SKILLING, HELLE, CHRISTIANSEN, ROBERTSON — Structural & Civil Engineers

PROJECT: THE WORLD TRADE CENTER | TITLE: REPAIR AT EL. 310' | DATE: 5-24-72

12-JK7-20.1

Detail A

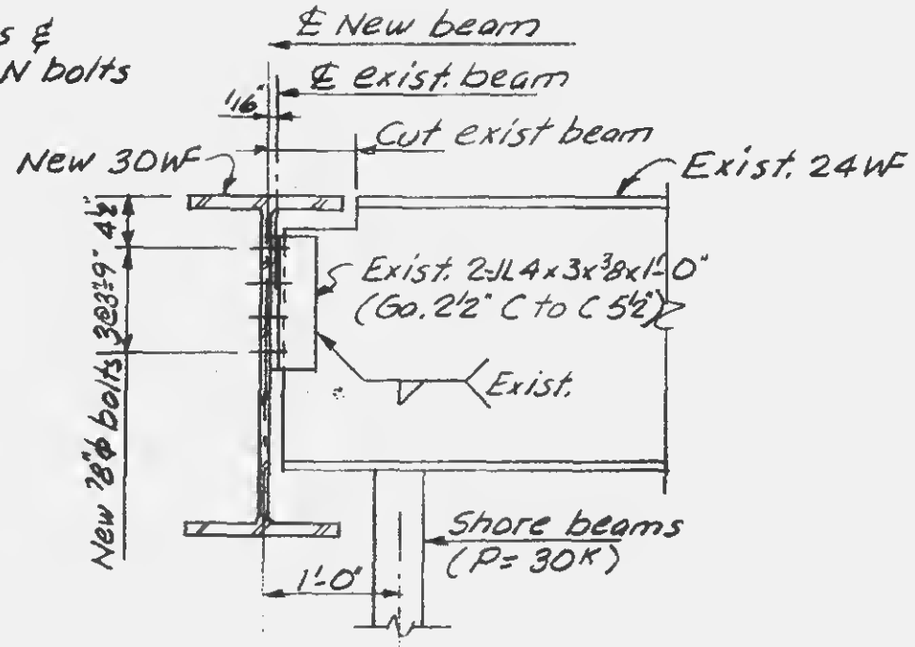
Note: Remove ⅞"ϕ exist. bolts & install new ⅞"ϕ A490-N bolts with new beam.
